This drawing depicts the error found within the metes-and-bounds Legal Description that is used in all current conveyances of the subject property. Please refer to the notes included with the title report.

Subject Property Physical Address: 1130 Kingston Drive

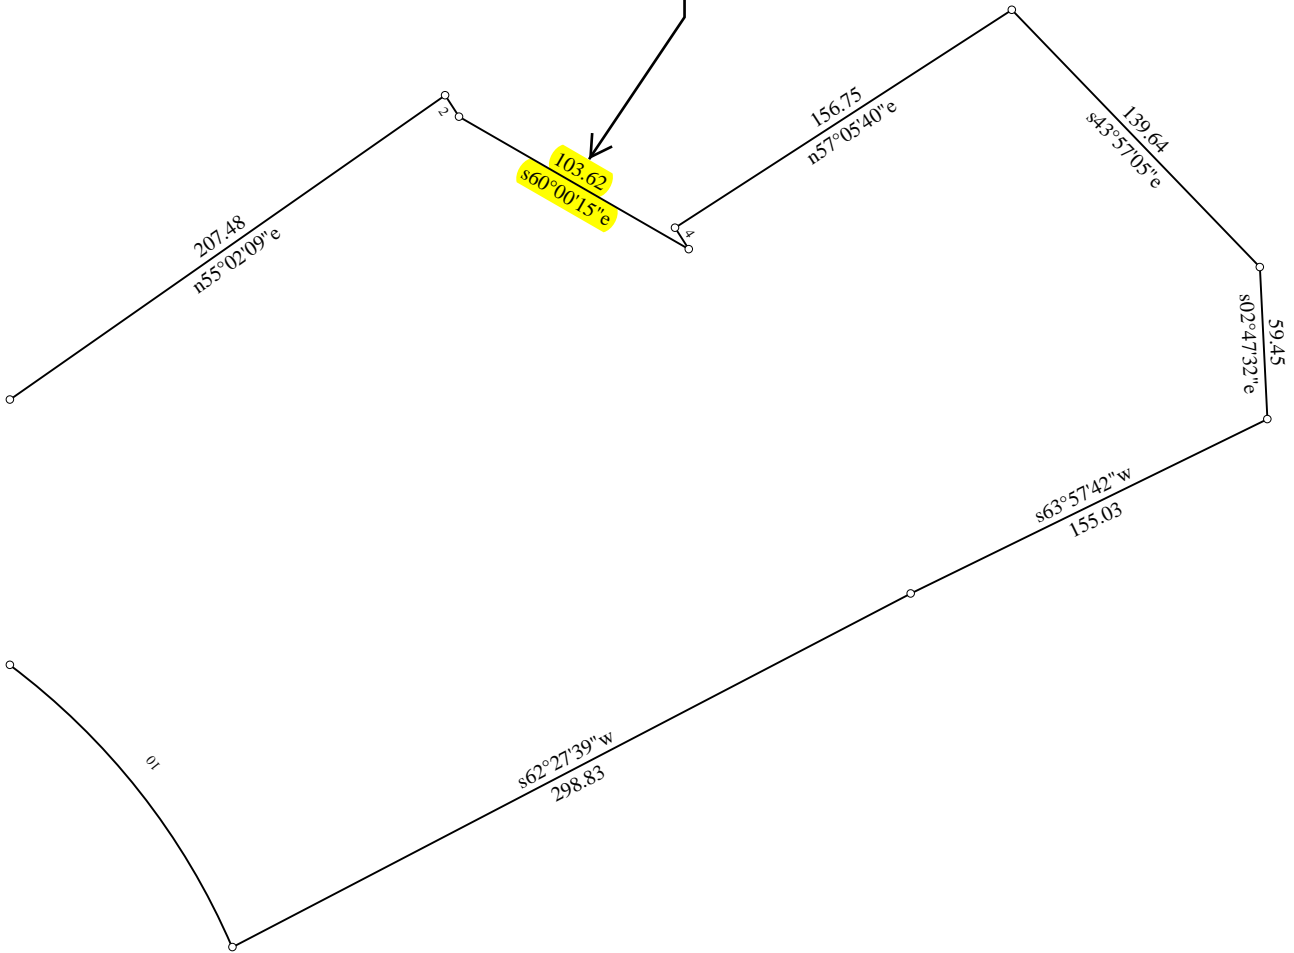
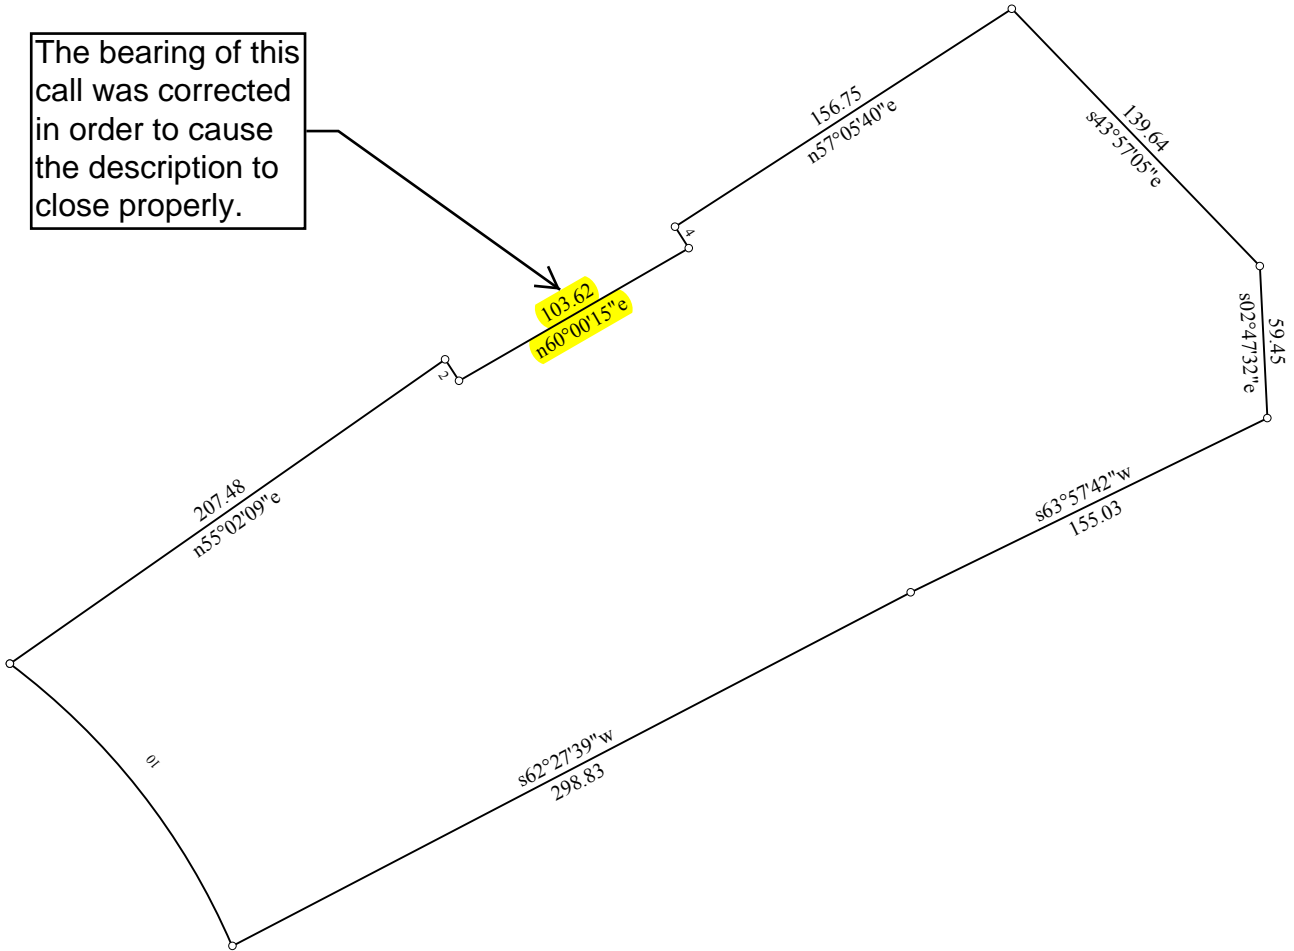
The bearing of this call is incorrect within the Legal Description currently of record.

This drawing depicts the correction that should be made to the metes-and-bounds Legal Description that is used in all current conveyances of the subject property. Please refer to the notes included with the title report.

The bearing of this call was corrected in order to cause the description to close properly.

003=n60.0015e 103.62
